# NORTH ANNA POWER STATION

*Unit 2 CTS  
Mark-Ups*

**VOLUME 3**

*Improved Technical Specifications*

Figure  
3.4.16-1

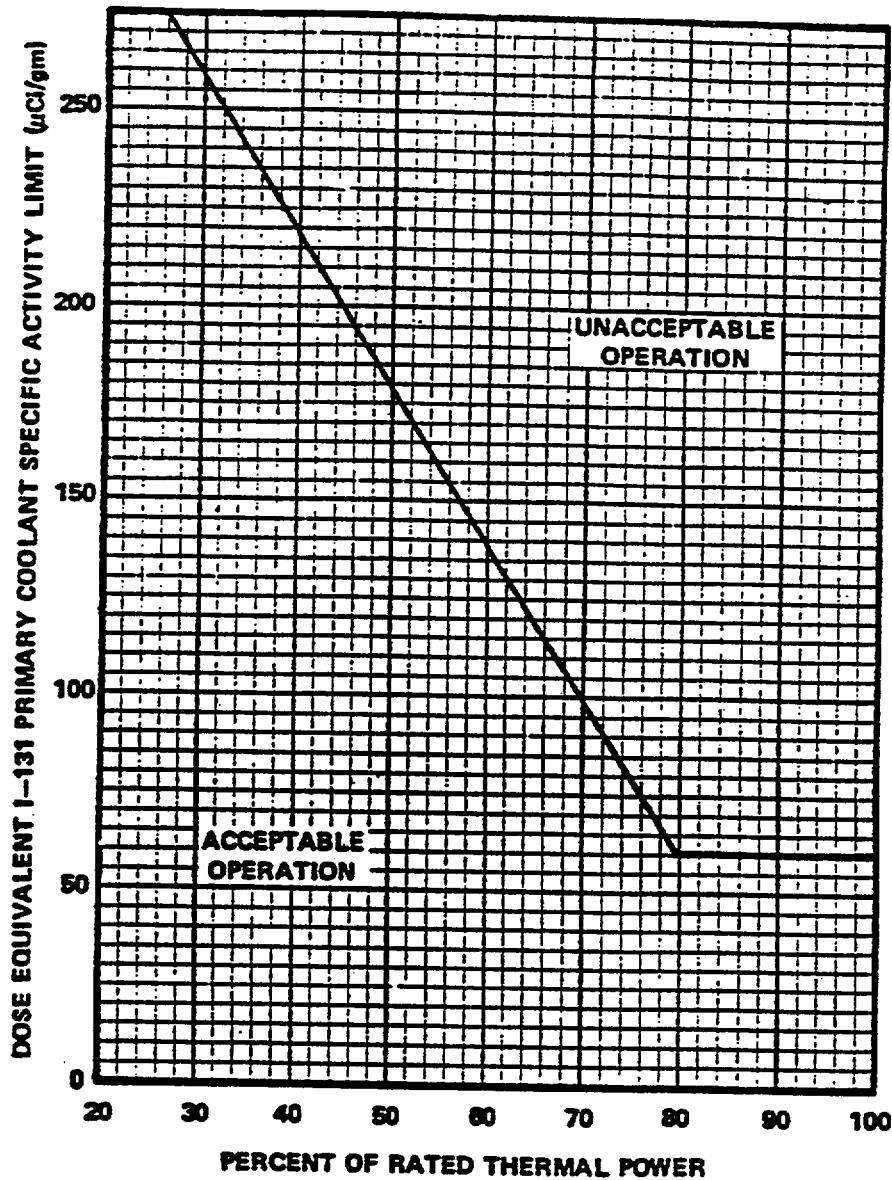
FIGURE 3.4-1

Figure  
3.4.3-3

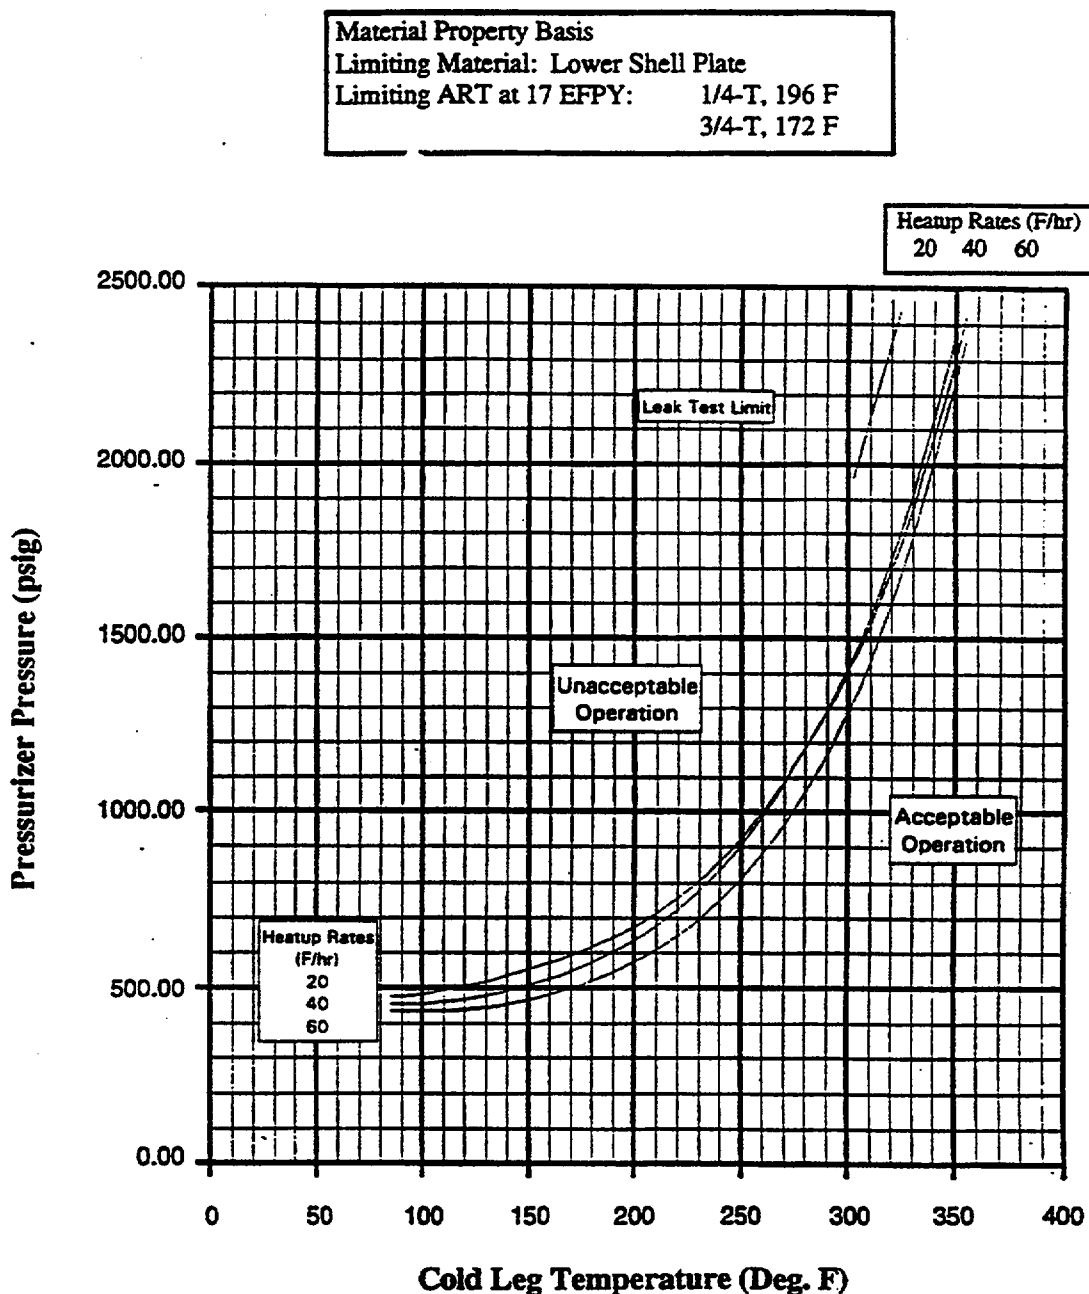
Figure 3.4-2 — North Anna Unit 2  
Reactor Coolant System Heatup Limitations

Figure  
3.4.3-4

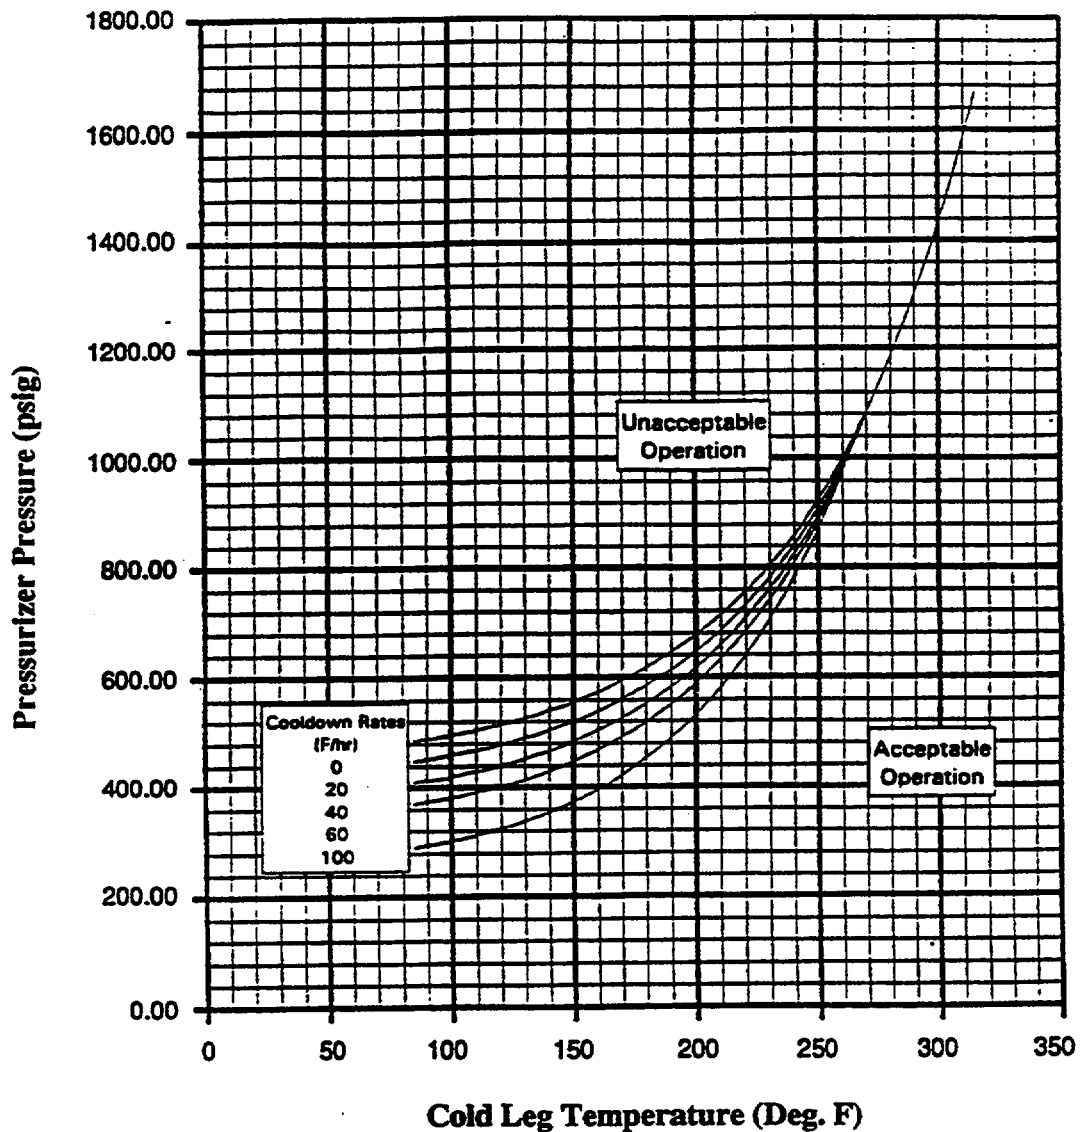
Figure 3.4-3 — North Anna Unit 2  
Reactor Coolant System Cooldown Limitations

Figure  
3.6.4-1

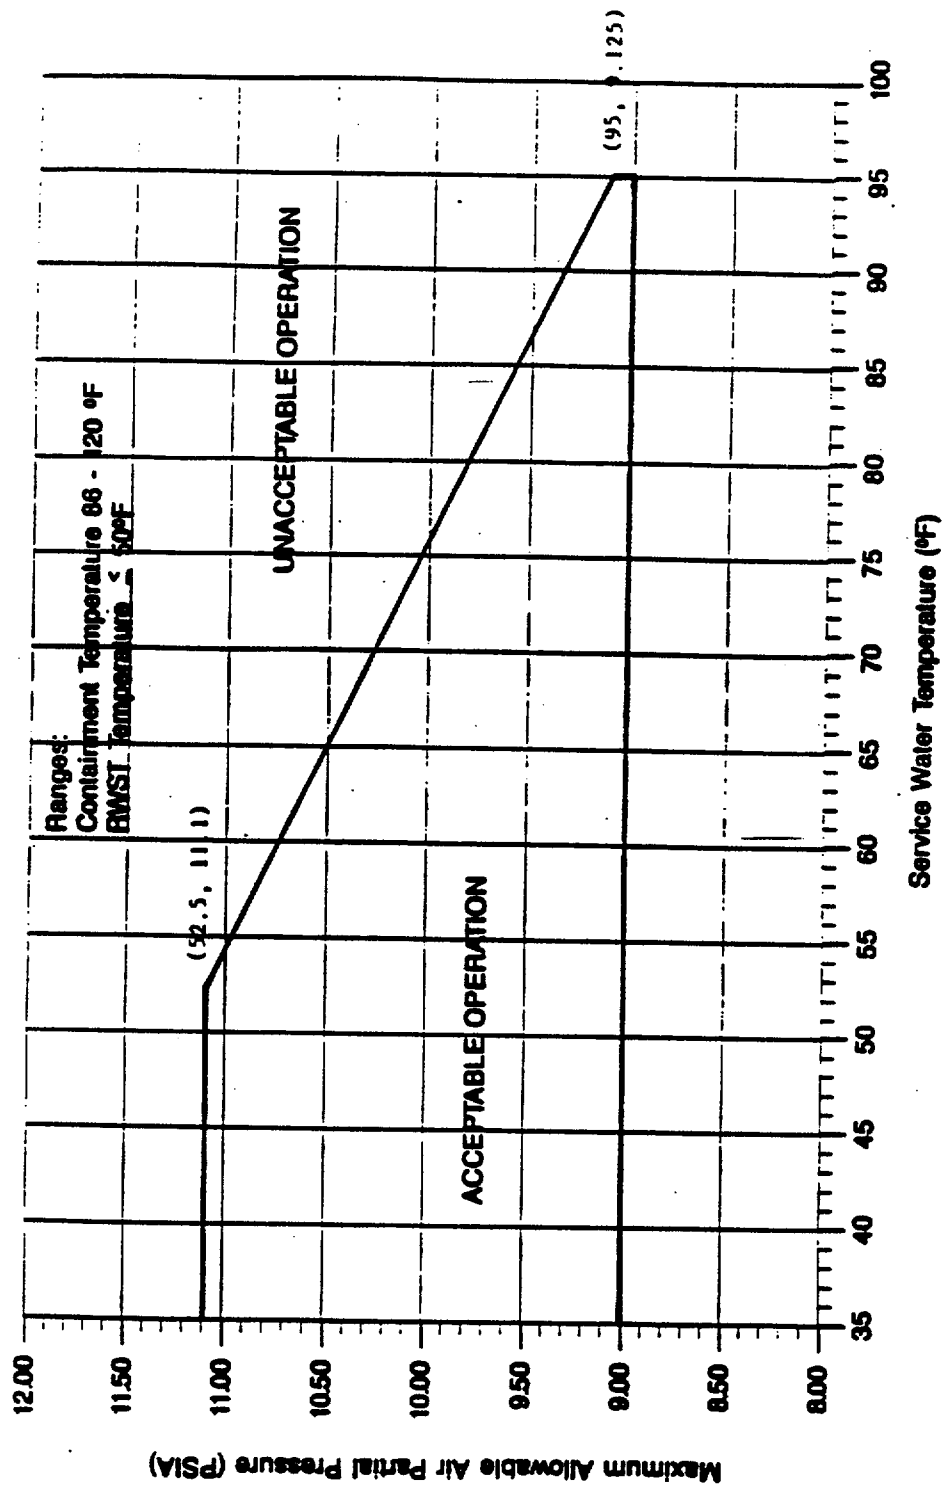
Figure 3.6-1  
Containment Air Partial Pressure Versus Service Water Temperature
